City of Ketchum

Recommendation to Hold a Public Hearing and Approve the Onyx at Leadville Residence: Phase 2 Final Plat

PROJECT: The Onyx at Leadville Residence: Phase 2

APPLICATION TYPE: Condominium Subdivision Final Plat

THE ONYX AT LEADVILLE RESIDENCE: PHASE 2
 GALENA ENGINEERING, INC.
 HAILEY, IDAHO
 SHEET 1 OF 3
 Job No. 7410.04

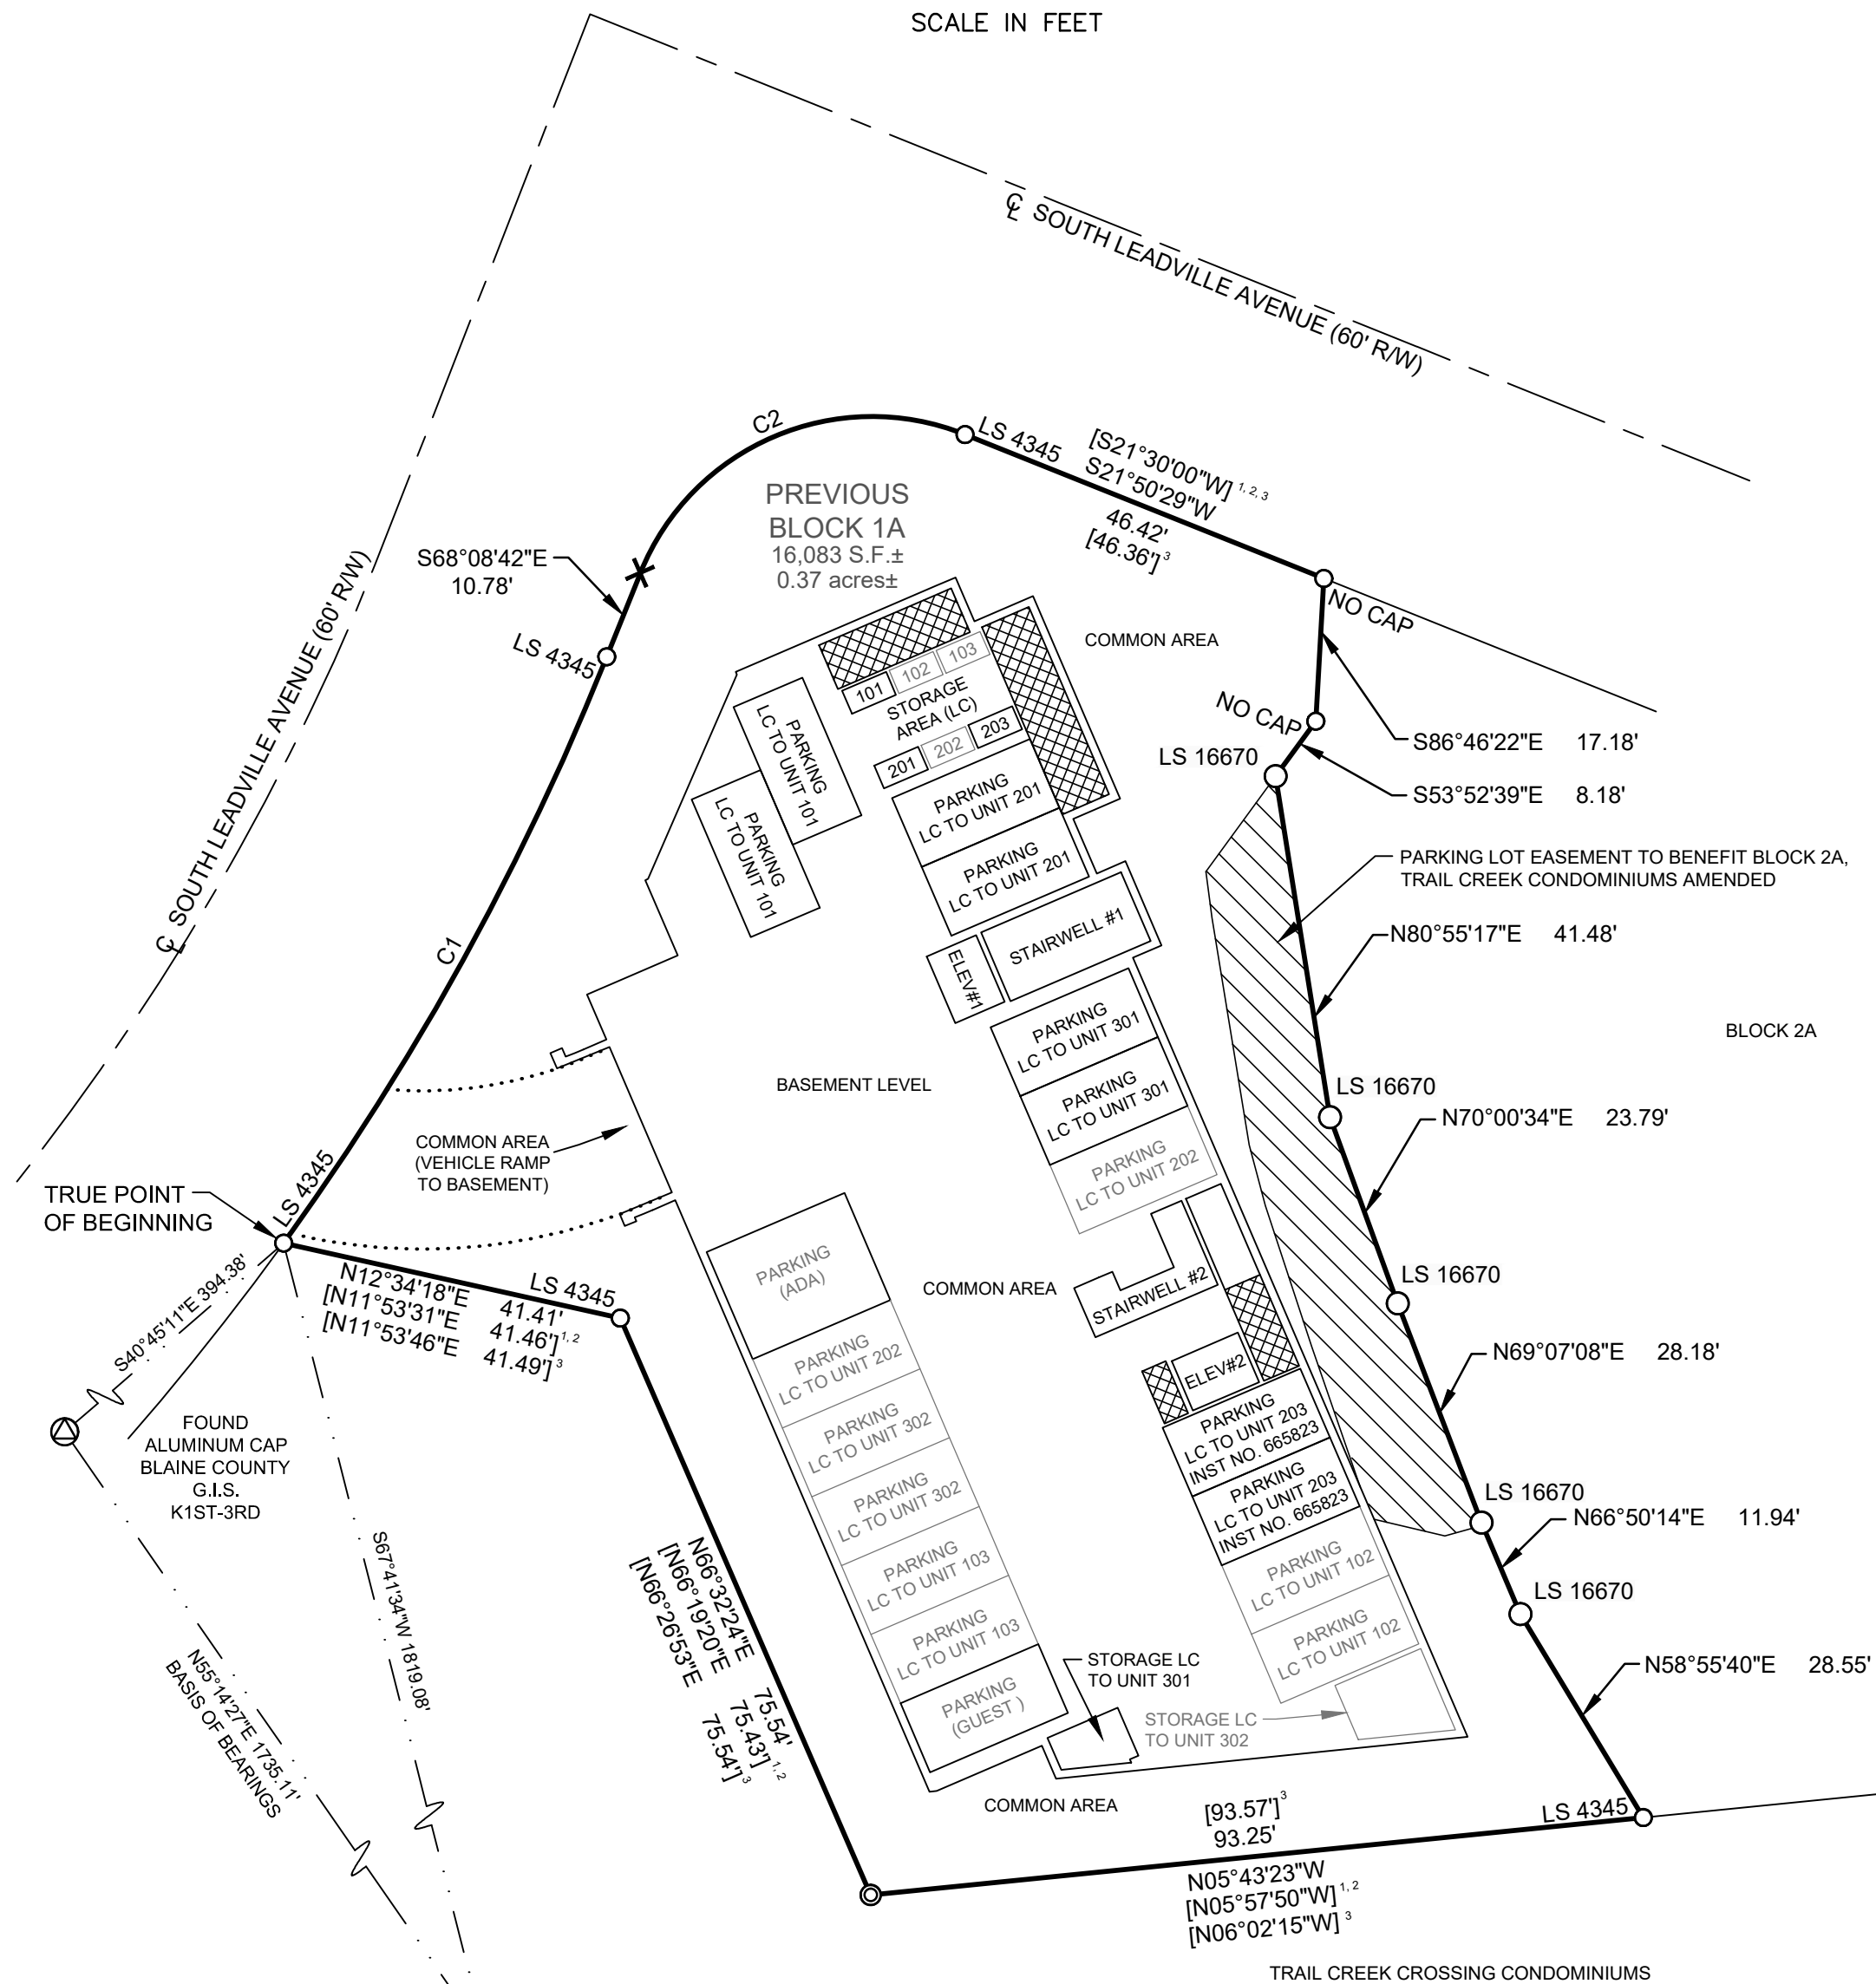
2. The Final Plat mylar shall visually represent the 5 ft public utility easement as required pursuant to KMC §16.04.030.J10.
3. Pursuant to KMC §16.04.070.C, the final plat shall not be signed by the City Clerk and recorded until the condominium has received: Certificates of Occupancy issued by the City of Ketchum for Units 101, 201, and 301.

4. The recorded plat shall show a minimum of two Blaine County Survey Control Monuments with ties to the property and an inverse between the two monuments. The Survey Control Monuments shall be clearly identified on the face of the map.
